**Work Order ID 69249**

Item Name: Crosstube Turning Detail

DRAWING NO. D412-664-243	TITLE CROSSTUBE ASSEMBLY (412 HI AFT)	REV. E	DART AEROSPACE LTD ENGINEERING ORDER		D.E.O. NO. D412-664-243-E-1	SHEET NO. SHEET 1 OF 2	SCALE NTS
DRAWN	CHECKED <i>MP</i>	MFG. APPR. <i>E</i>	APPROVED <i>MP</i>	DE APPR. <i>MP</i>			
DATE 11.03.31	DATE 11/03.31	DATE 11.03.31	DATE 11/03.31	DATE 11.03.31

REMOVED ABRASION STRIP IN FAVOR OF A THIN LAYER OF PROSEAL 890.

**D412-664-243  
ASSEMBLY DETAIL**

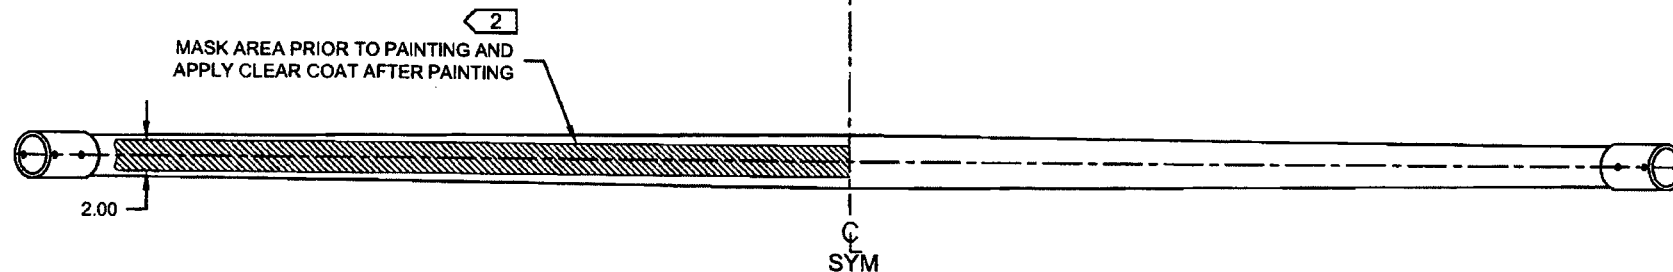
D3189-1 CHAFING SHIELD (1, INSTALLED OVER PROSEAL 890)  
MS21920-28 CLAMP, 2X  
2 PL

D2856-600-1009 ABRASION STRIP  
D3189-1 CHAFING SHIELD (1, INSTALLED OVER ABRASION STRIP)  
MS21920-28 CLAMP, 2X  
2 PL
